Product/Process Change Notice (PCN)

PCN #: PCN_ConMJ_20180319

Product Affected: ConMJ

For process improvement purposes, Würth elektronik will transfer manufacturing site of the below references leading to minor evolution in design.

P/N 634 008 137 521

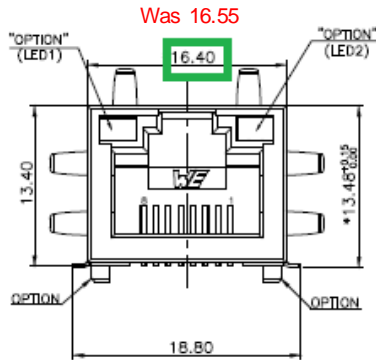
DETAIL OF CHANGES:
